INDIANA DEPARTMENT OF TRANSPORTATION

FINAL DRAFT MINUTES

April 16, 2026, Standards Committee Meeting

RE: Minutes from the April 16, 2026, Standards Committee Meeting

E 801-TCLC-02 Long-Term Stationary Freeway Right Lane Closure (shown markups)

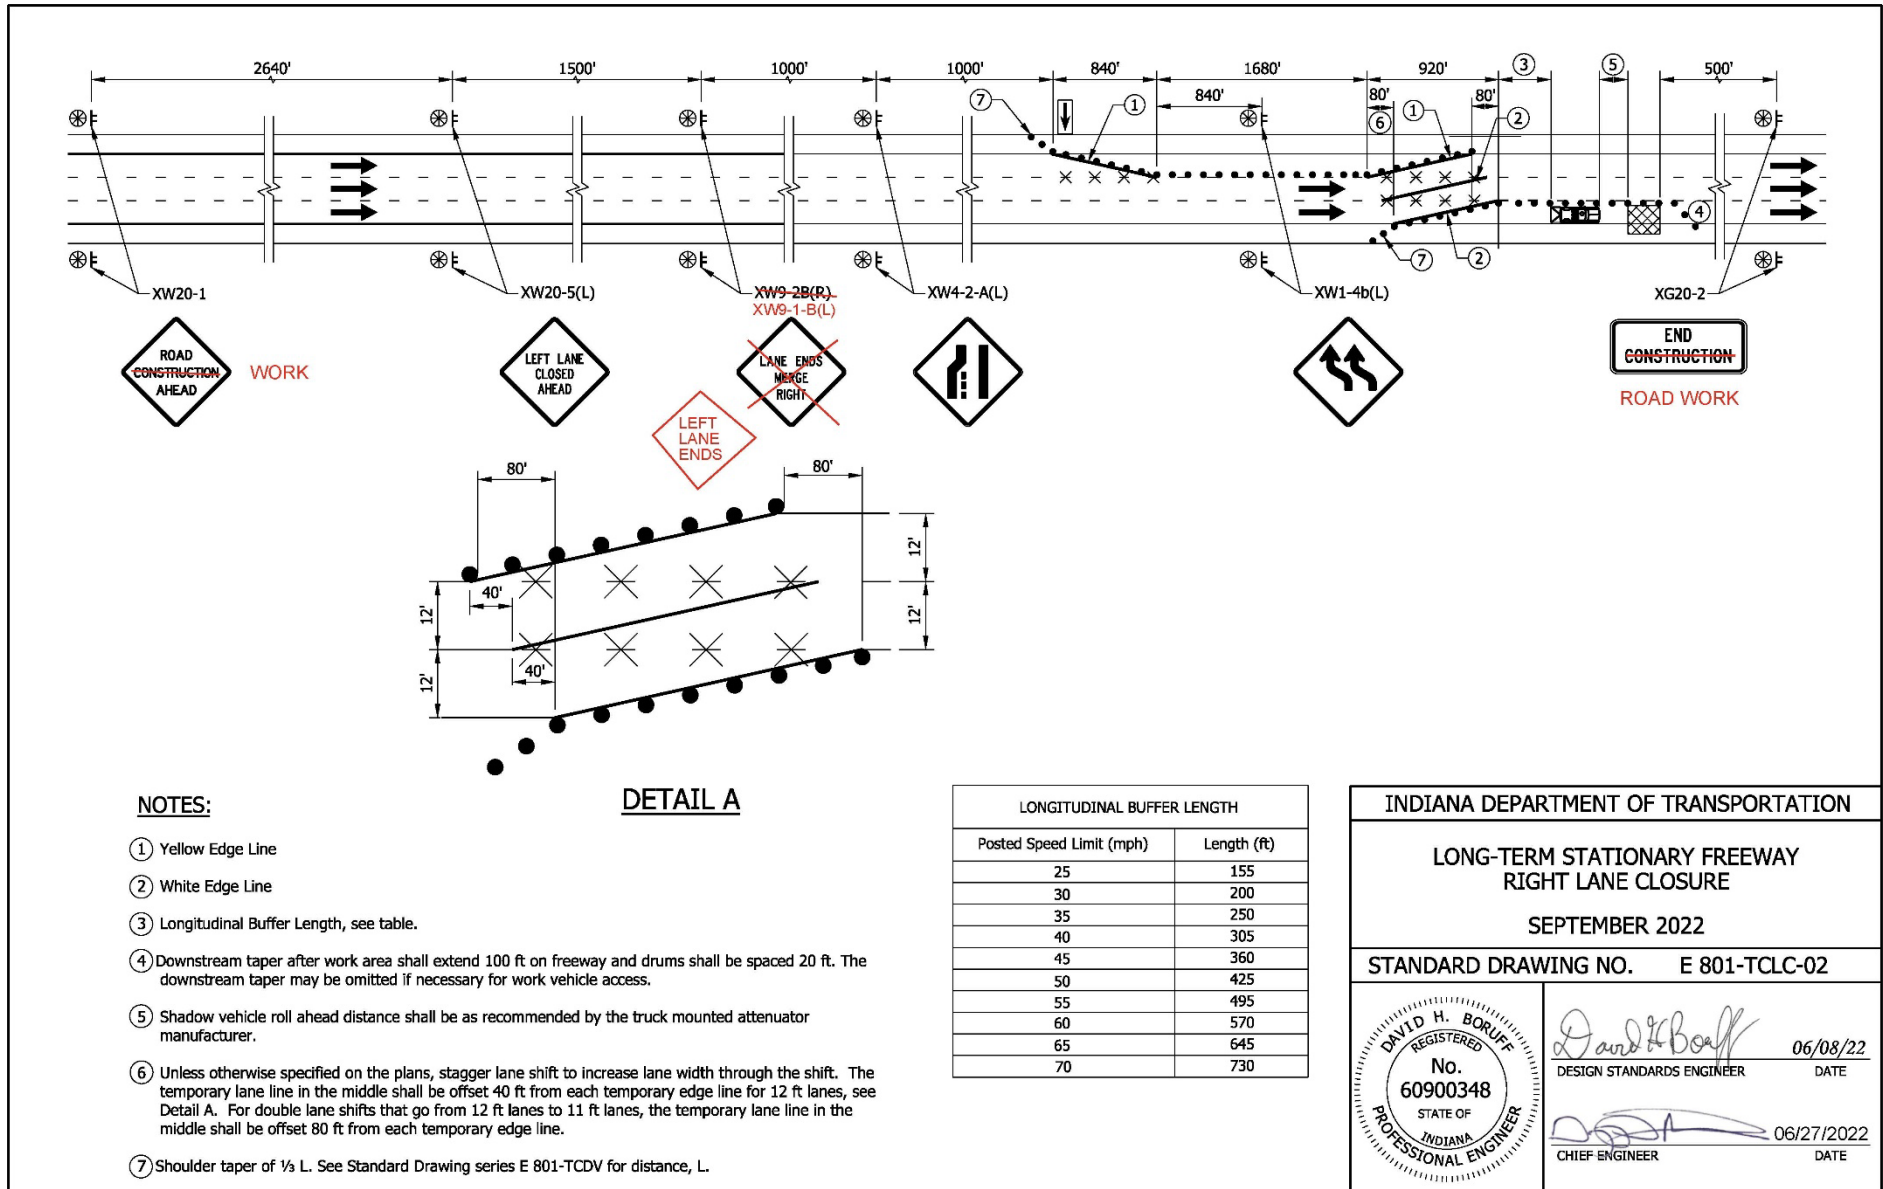
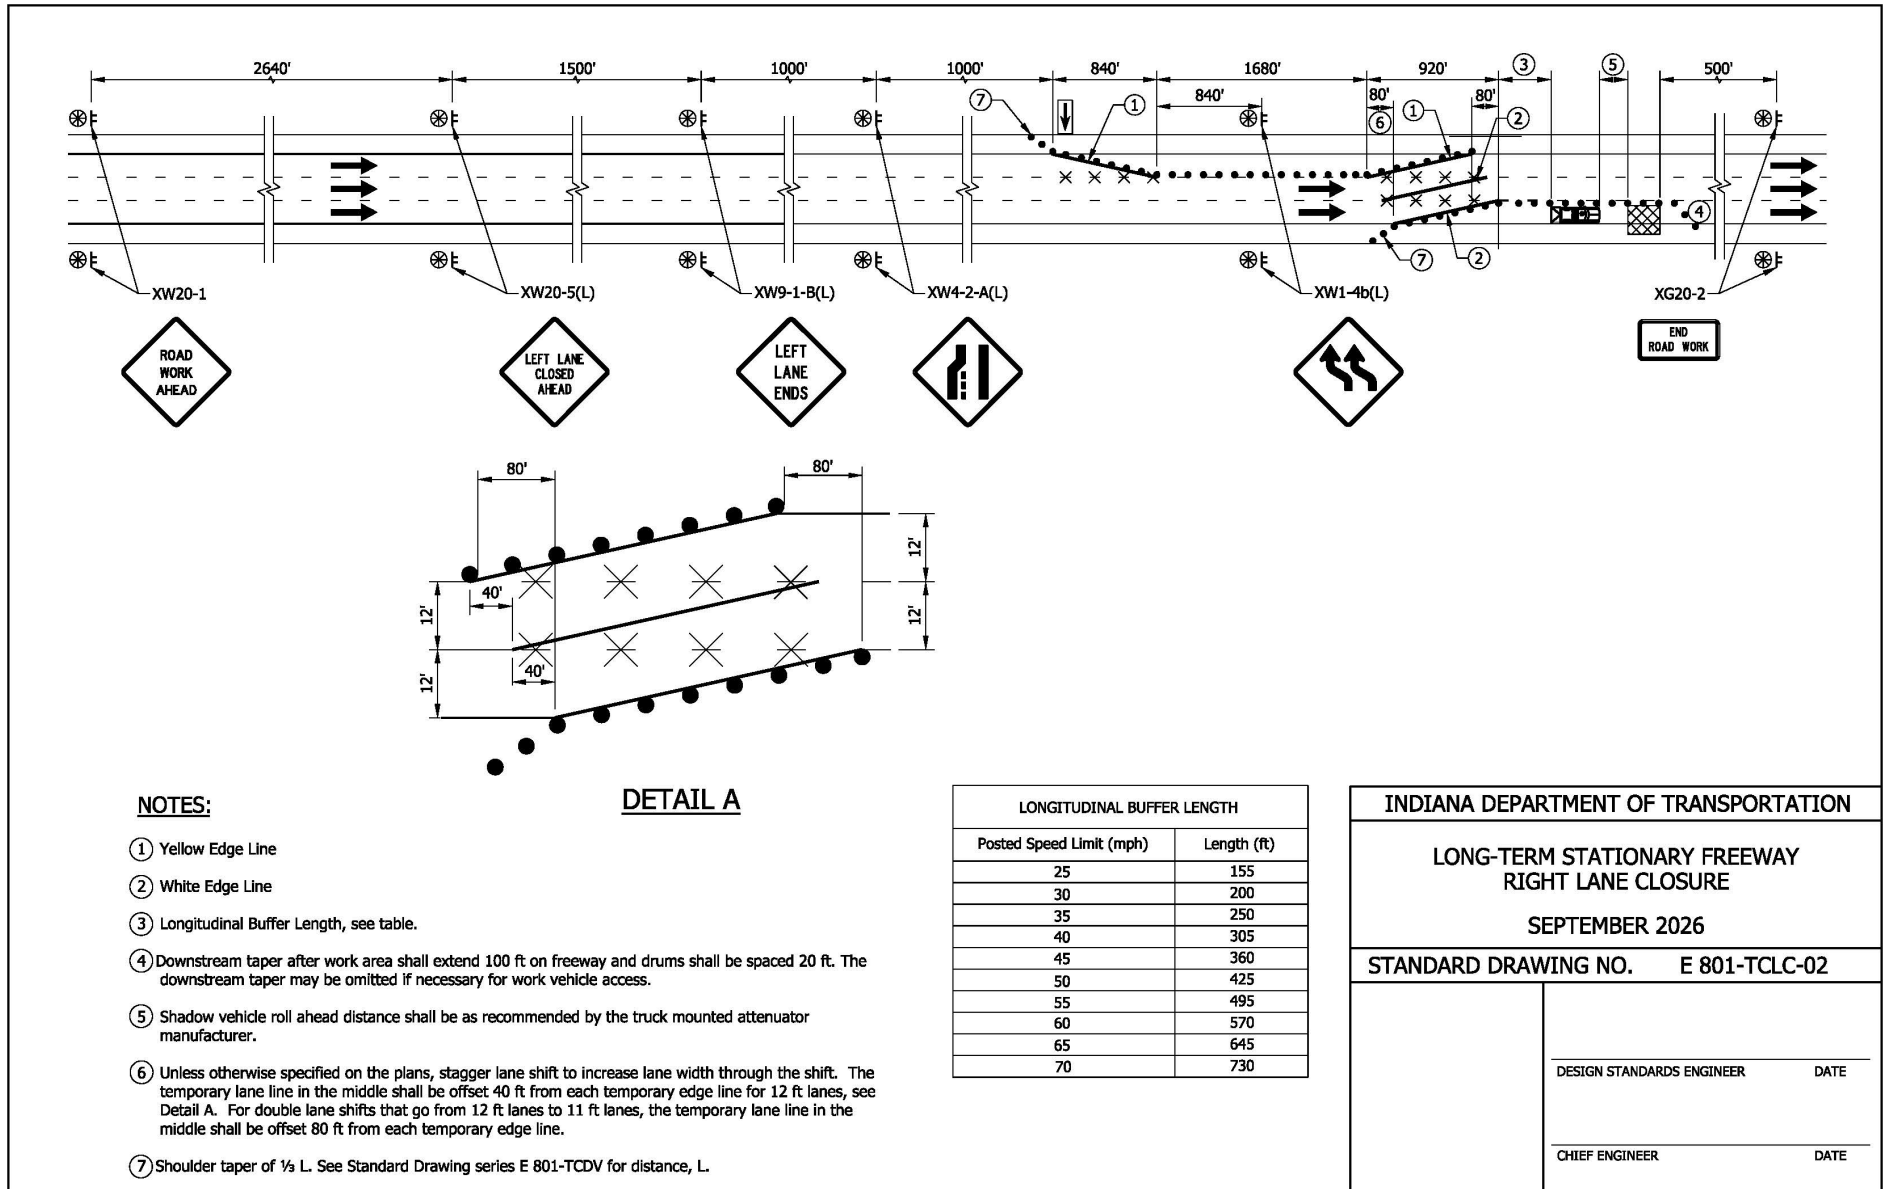
PROPOSED SOLUTION: Update these Standard Drawing series for the current edition of the MUTCD.

E 808-DLIM-02 Dotted Lines for Freeway Acceleration Lanes (shown markups)

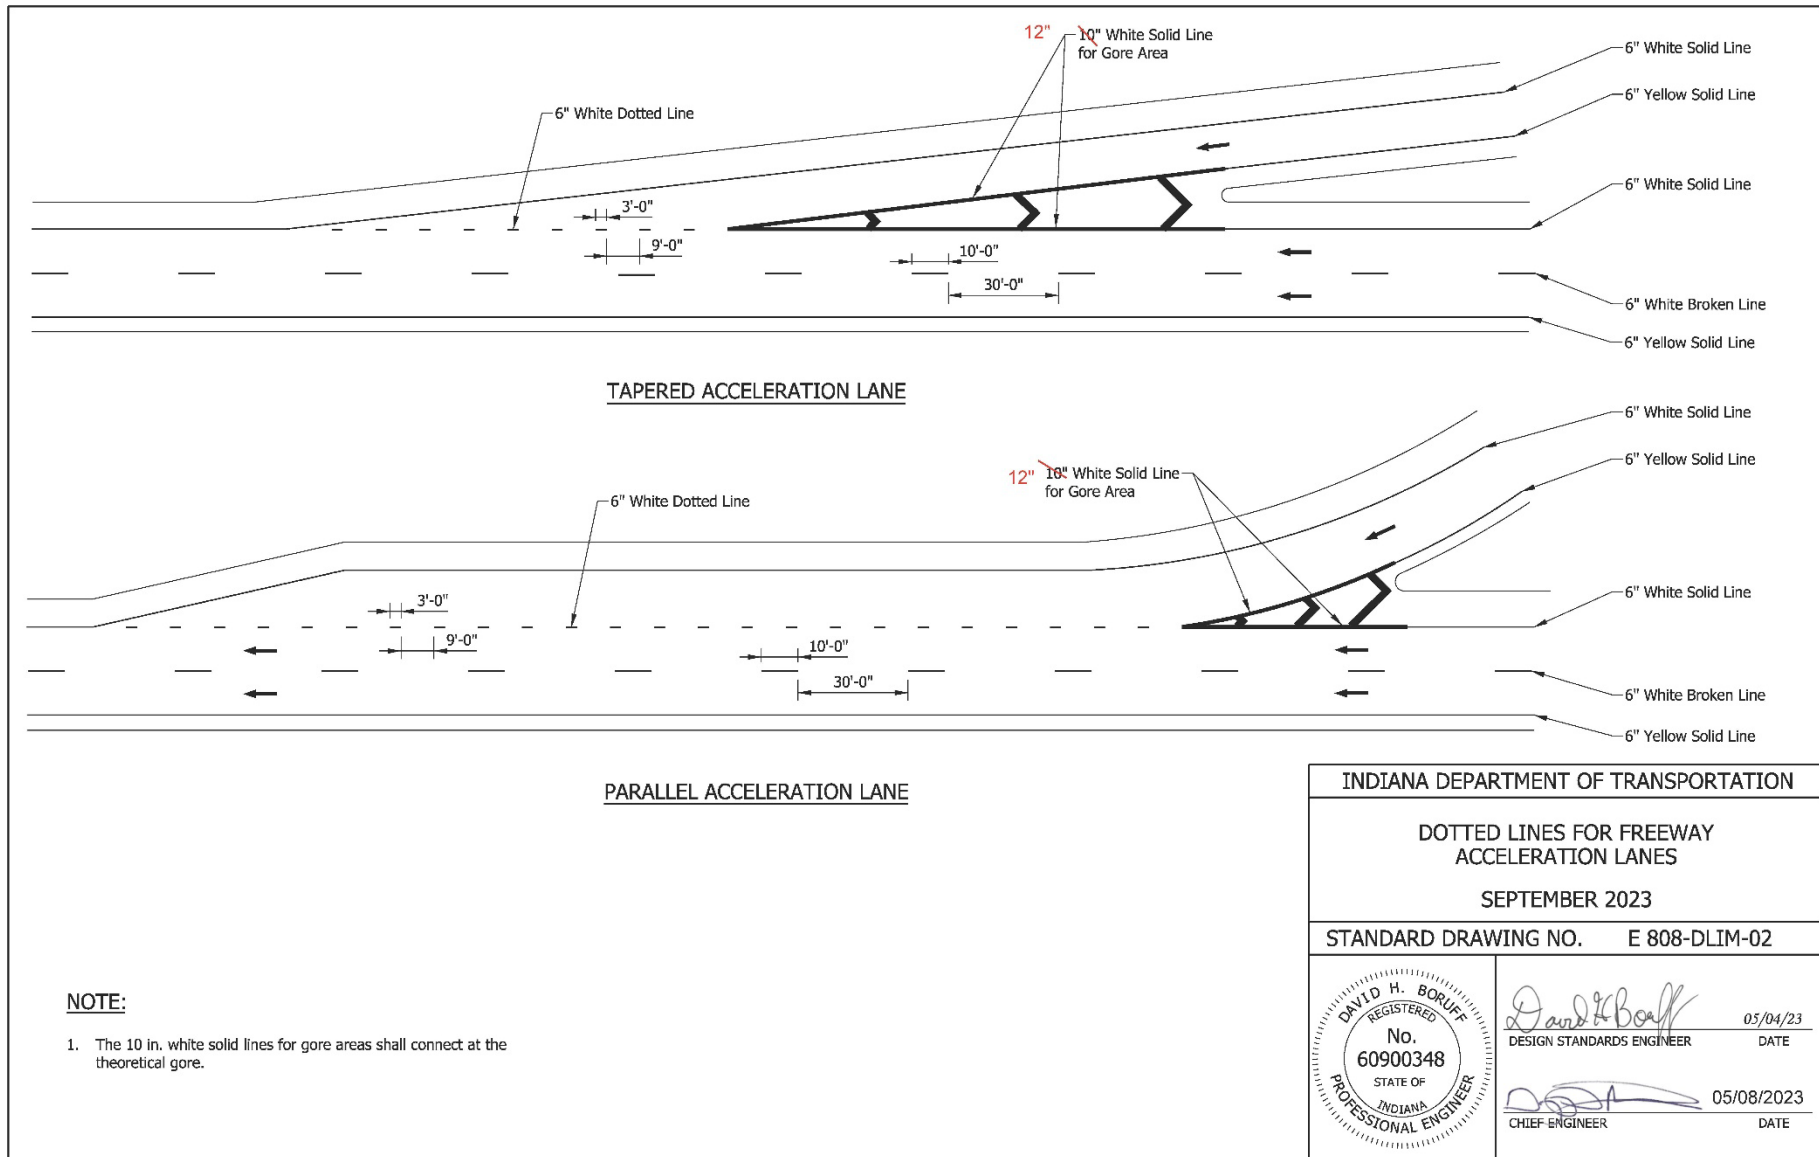
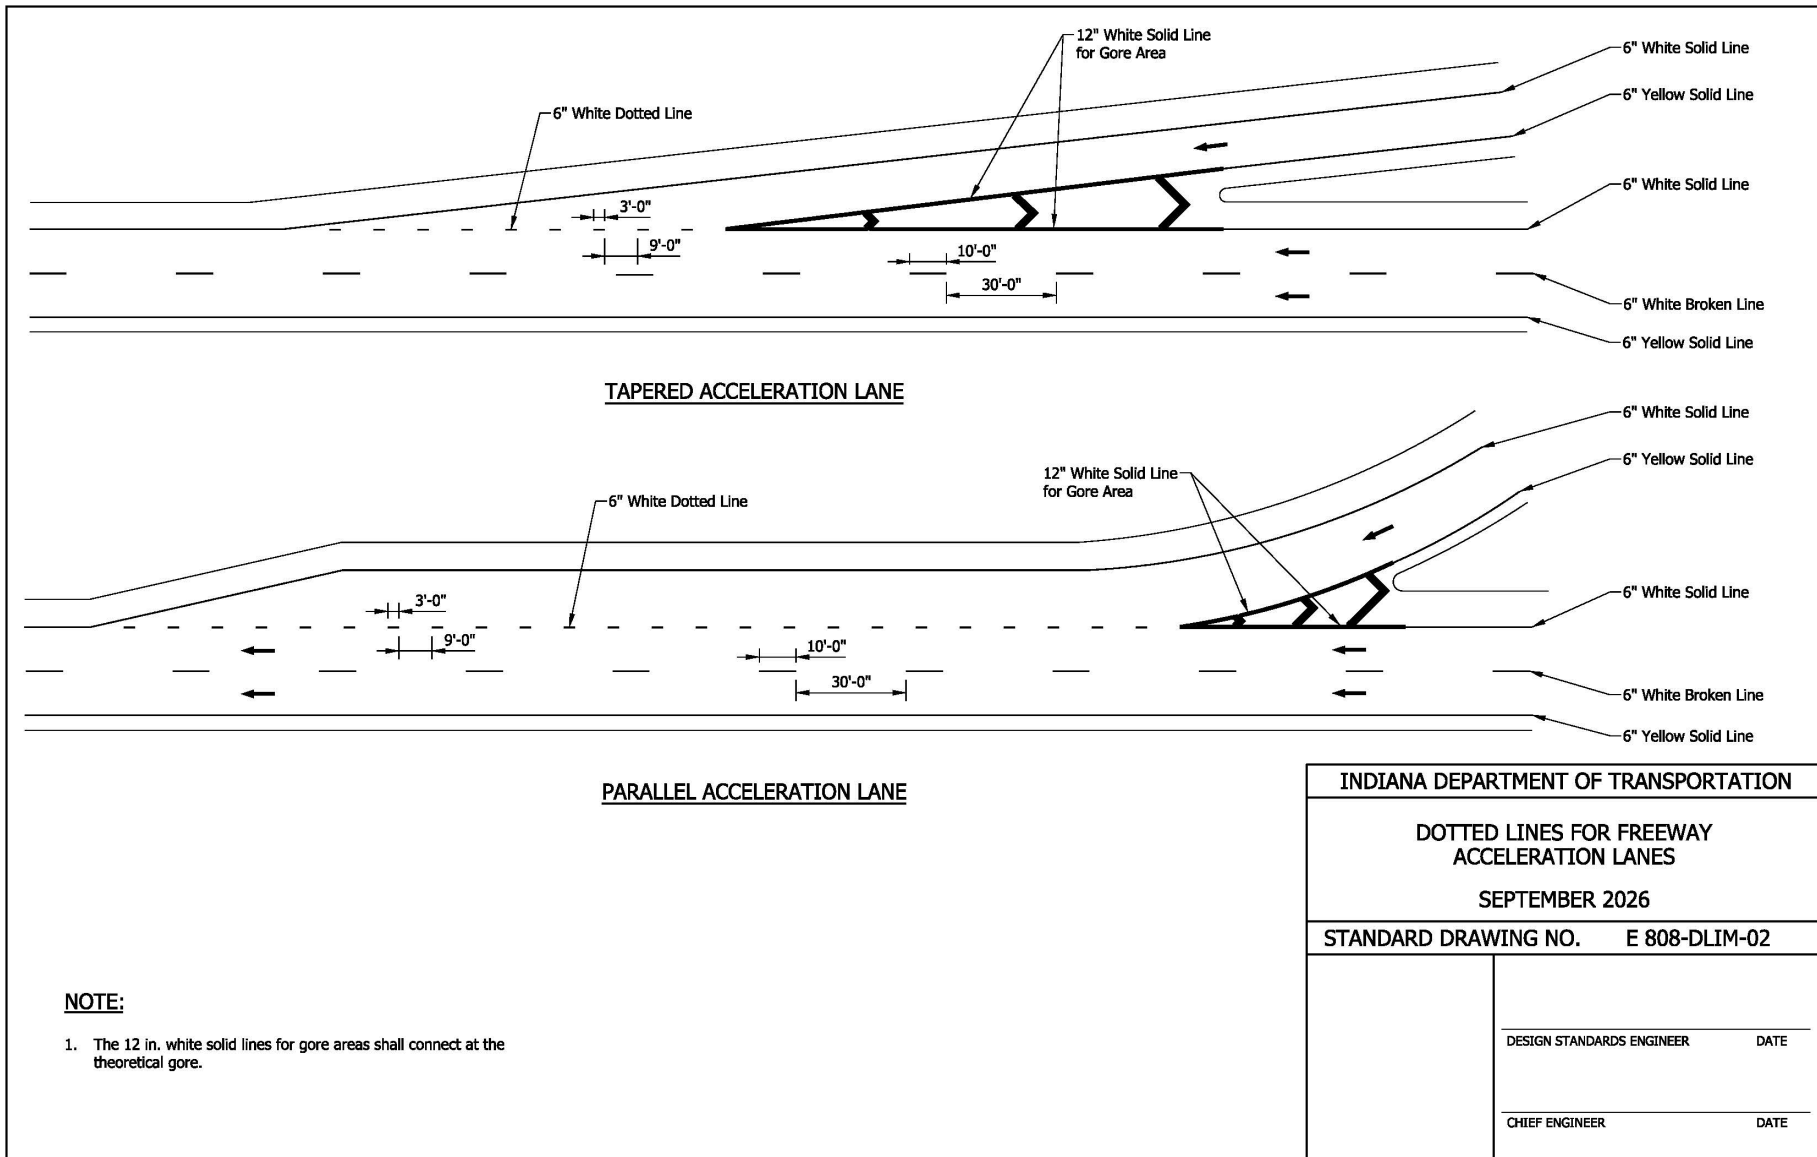
PROBLEM(S) ENCOUNTERED: Section 1B.02 of the 11th edition of the MUTCD requires states to update standard drawings to be in substantial conformance with the MUTCD. The 808-DLIM Standard Drawing series need various minor updates for the current edition of the MUTCD and the table in Standard Drawing 808-MKPM-06 needs to be updated for the current edition of the MUTCD.

REVISION TO STANDARD SPECIFICATIONS AND STANDARD DRAWINGS
E 808-MKPM-06 Transverse Markings Railroad Crossings (proposed draft)

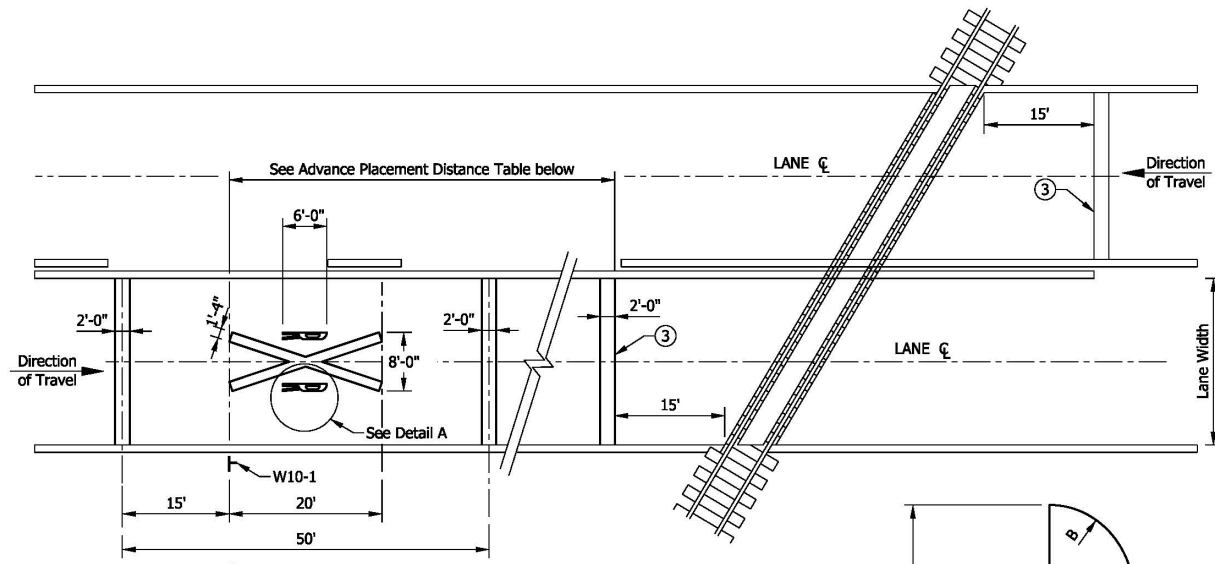
Mr. Koch stated that it seems Note #3 on sheet E 808-MKPM-06 could be problematic. I believe the Advanced Placement Table was created by INDOT based on the MUTCD. Yet changes could happen that go unnoticed. Should we remain silent and strike note #3 as we do not otherwise note each drawing with 'in accordance with the MUTCD'? Mr. Koch clarified that he is an engineer, not a lawyer.
